ANTELOPE VALLEY LINE CAPACITY AND SERVICE IMPROVEMENTS PROGRAM

**Metro**

# ES. Executive Summary

**Figure 3.4-1: Balboa Double Track Extension Site CNDDB Occurrences Within One Mile**

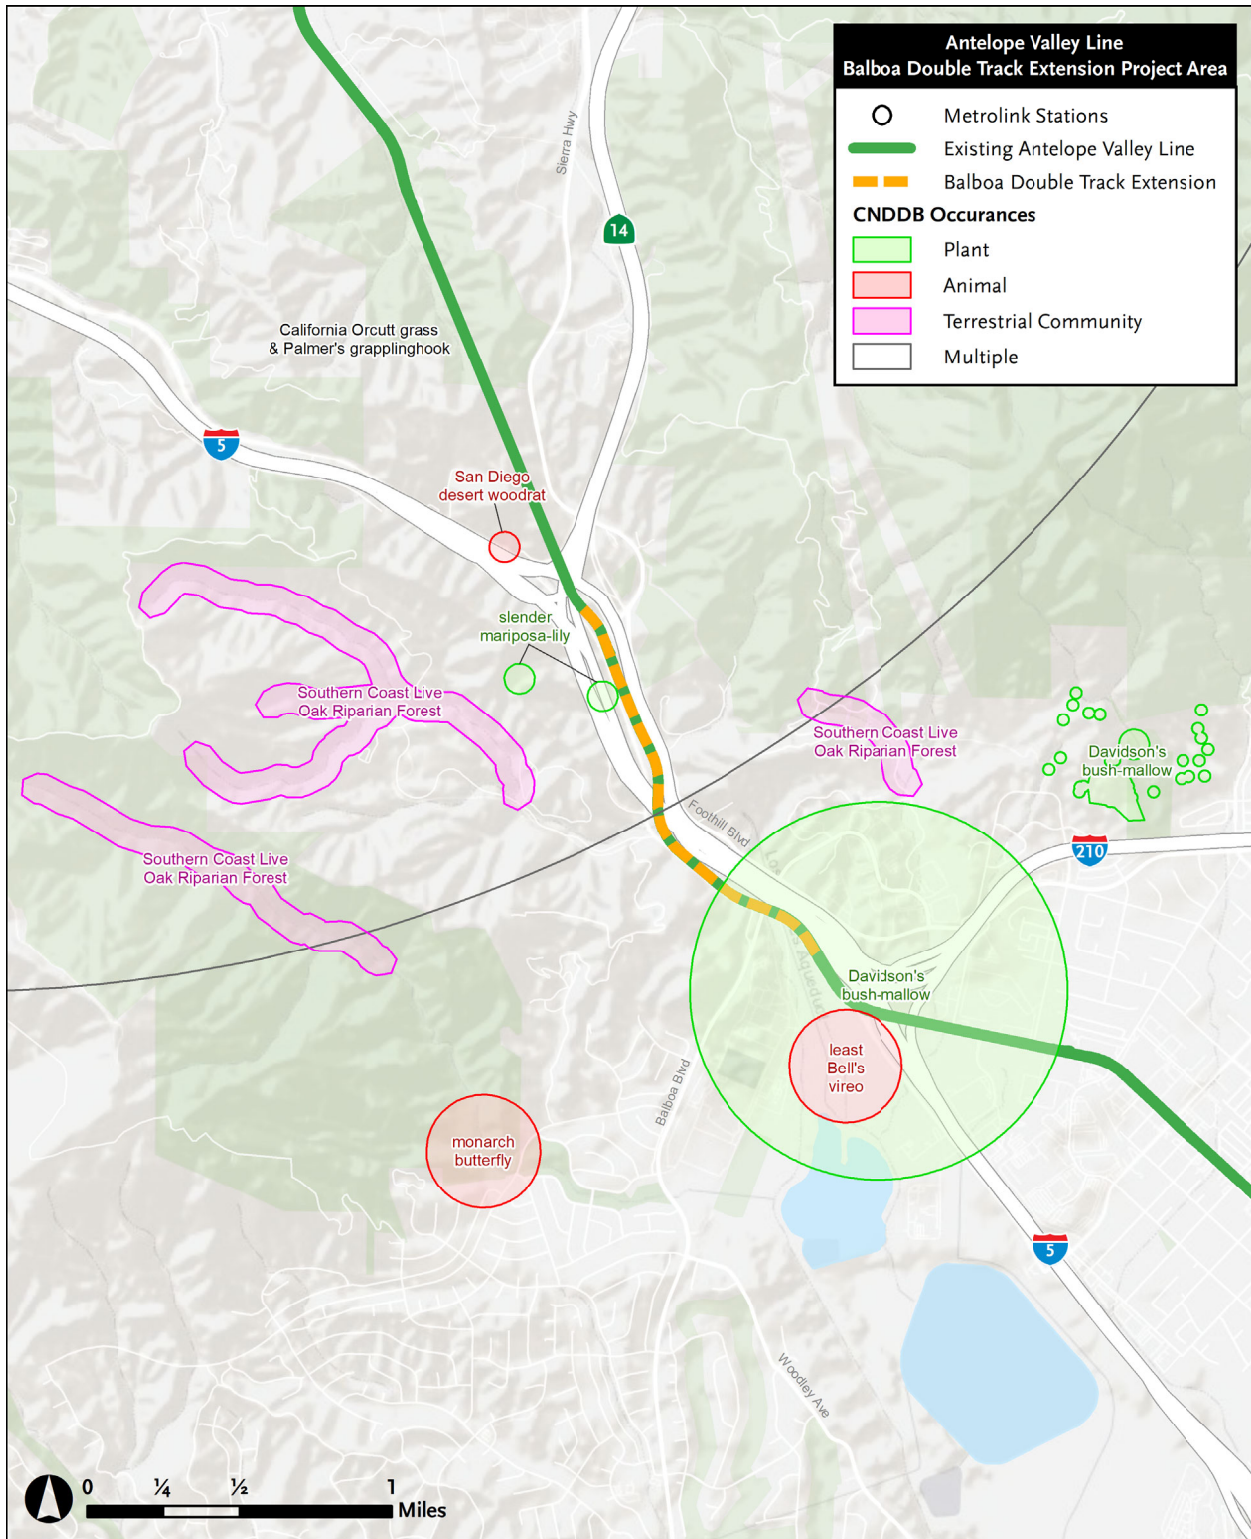
Page 3.4-4, the following paragraph and associated table and figure have been added to the discussion under subheading 3.4.2.3, Special Status Species:
